Donald C. Cook Nuclear Plant Unit 2  
PROPOSED ALTERNATIVE TO THE  
AMERICAN SOCIETY OF MECHANICAL ENGINEERS CODE, SECTION XI  
REPAIR REQUIREMENTS  
REQUEST FOR ADDITIONAL INFORMATION

Relief Request ISIR-20  
Response to Nuclear Regulatory Commission  
Request for Additional Information

Figure 1, Page 3 of 3

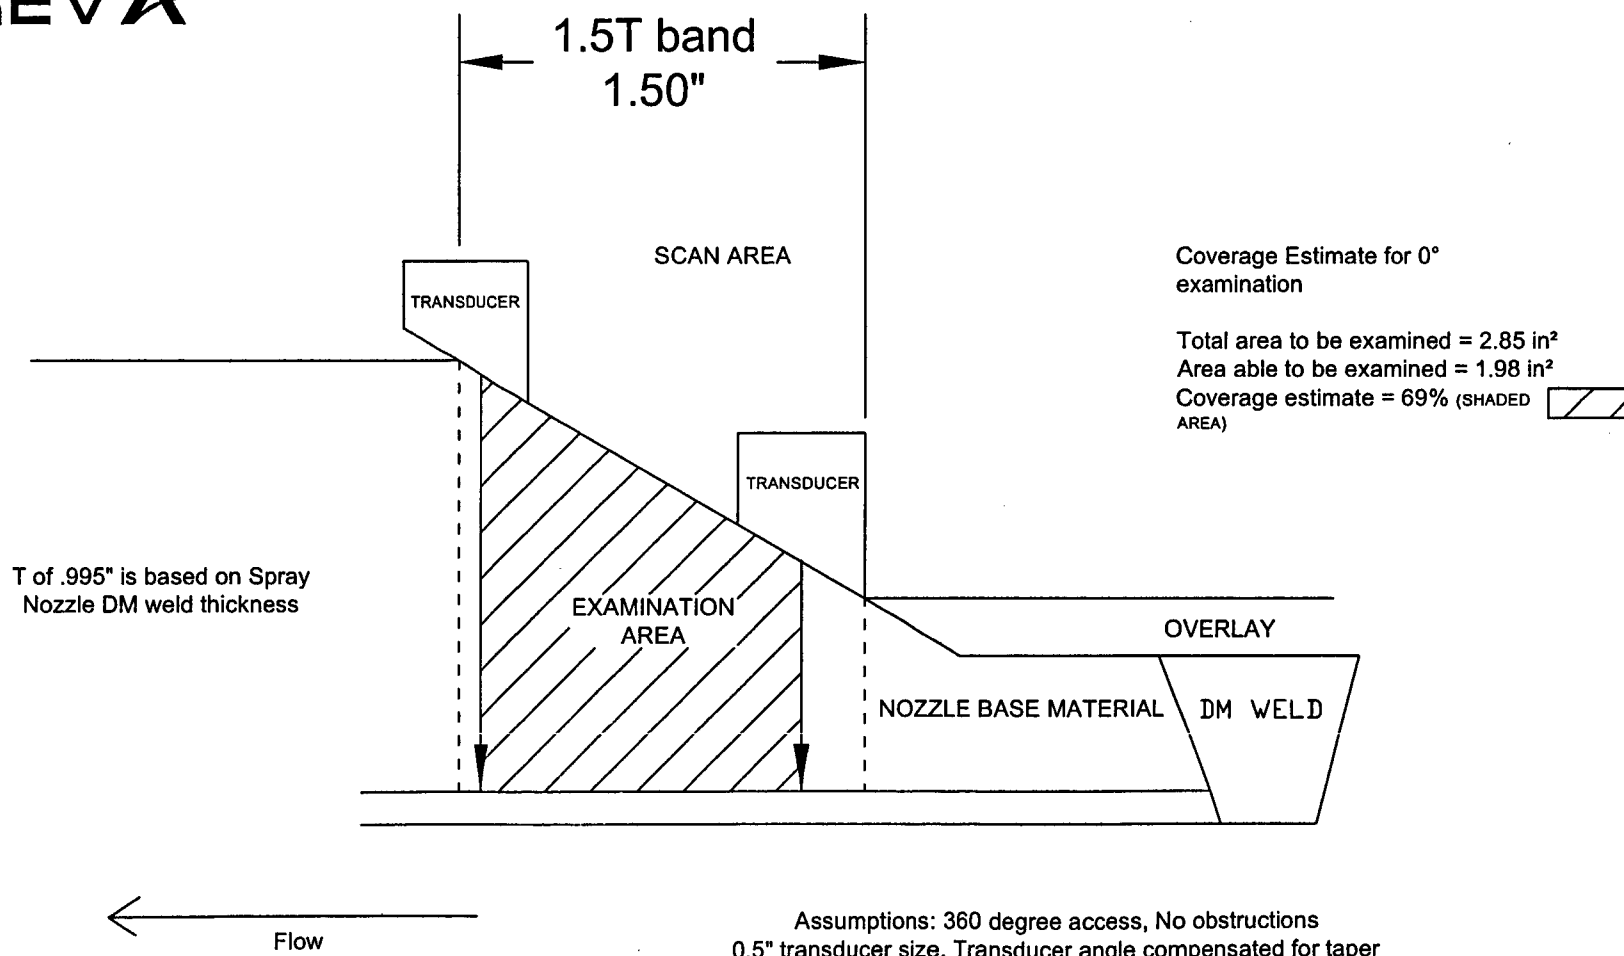
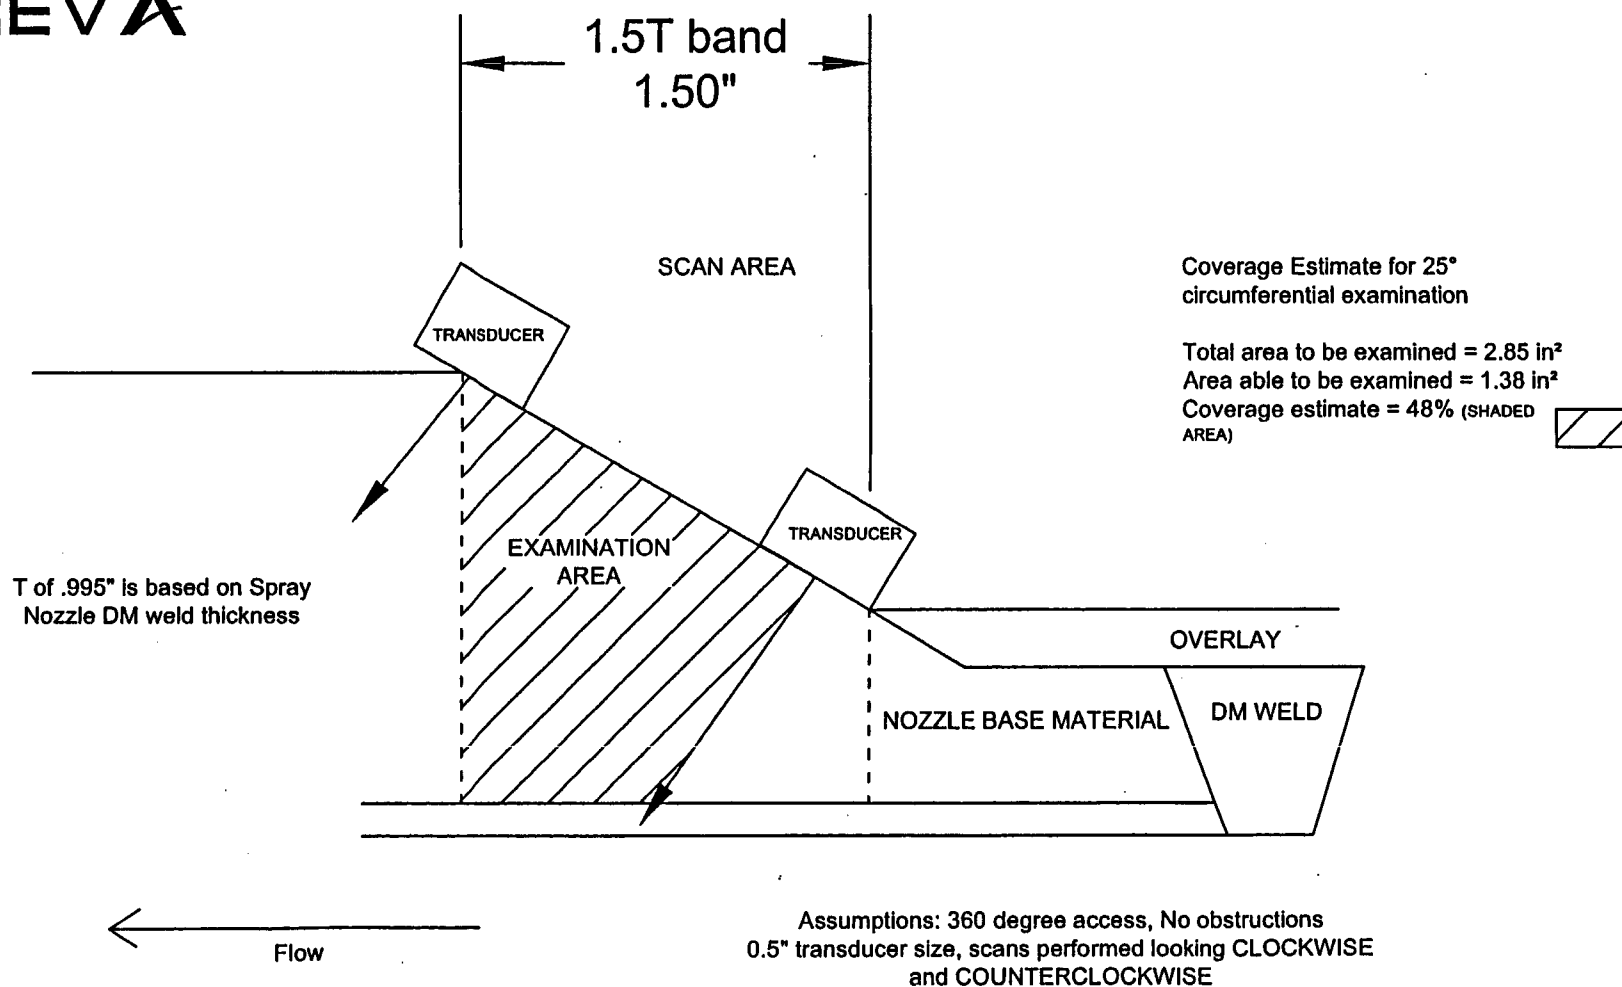
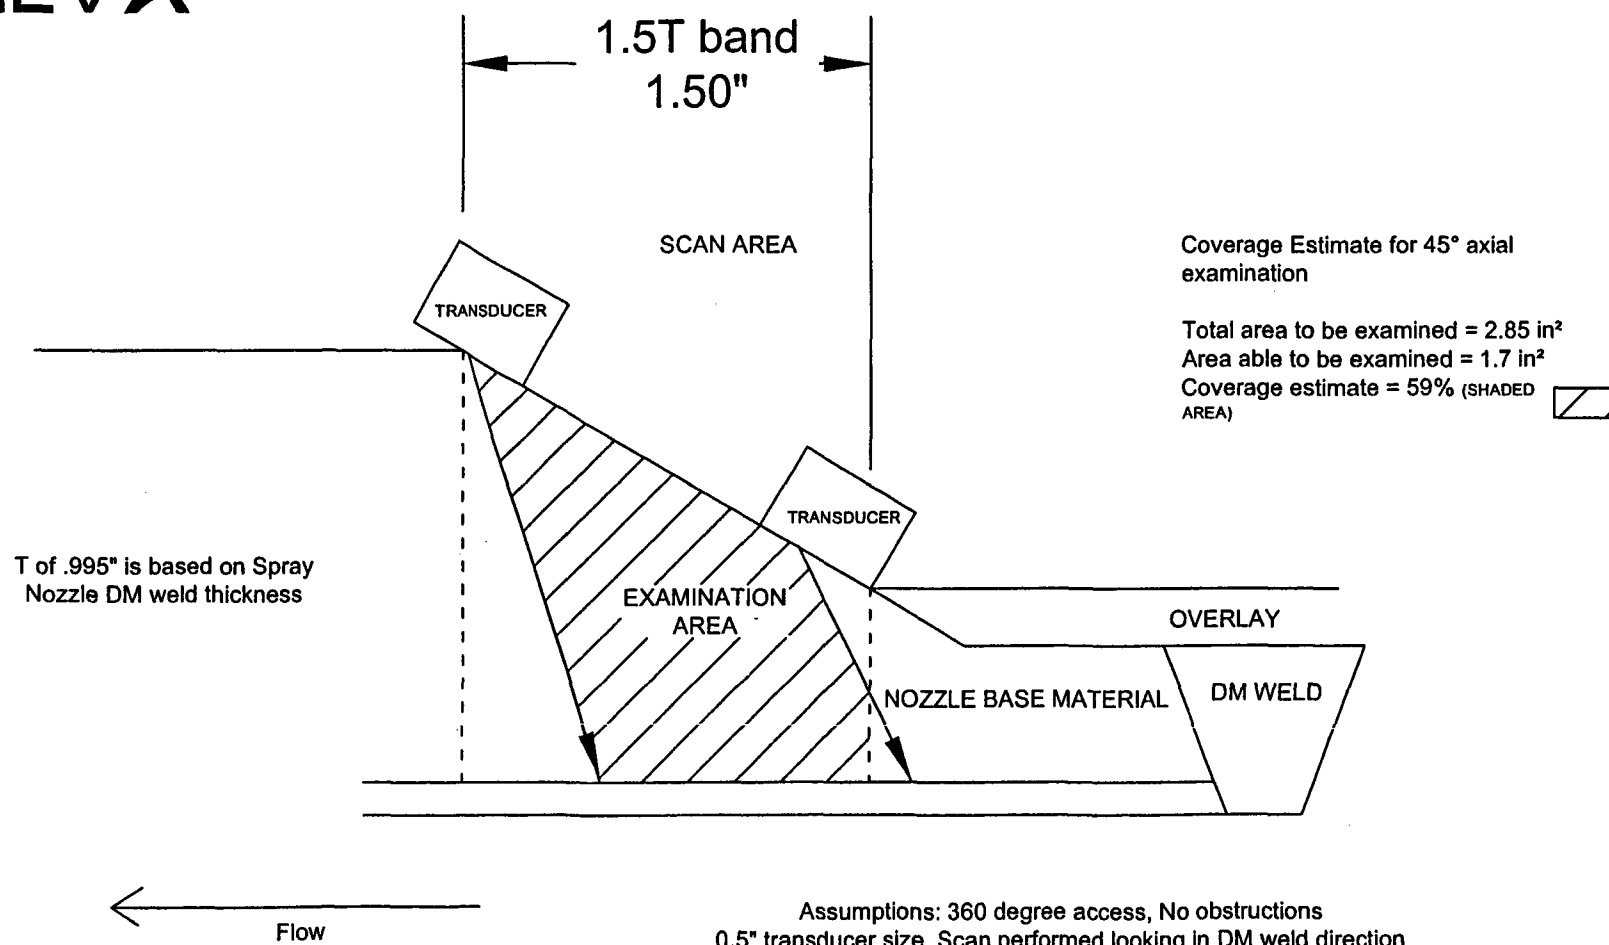
*Provide additional information to support the statement that it is not possible to perform a meaningful ultrasonic (UT) examination of the 1.5T band of base material because of the existing nozzle configuration. The information should discuss the achievable amount of area that will be successfully examined for each design configuration that I&M wishes to apply a PWOL. Clarify whether the UT examination will be performed to the maximum extent achievable.*

The scans that will be performed are identified in Figure 1. It is estimated that the 0-degree scan will obtain 69 percent coverage of the area, the 25-degree circumferential scan will obtain 48 percent coverage of the area, and the supplemental 45-degree axial scan will obtain 59 percent coverage of the area.
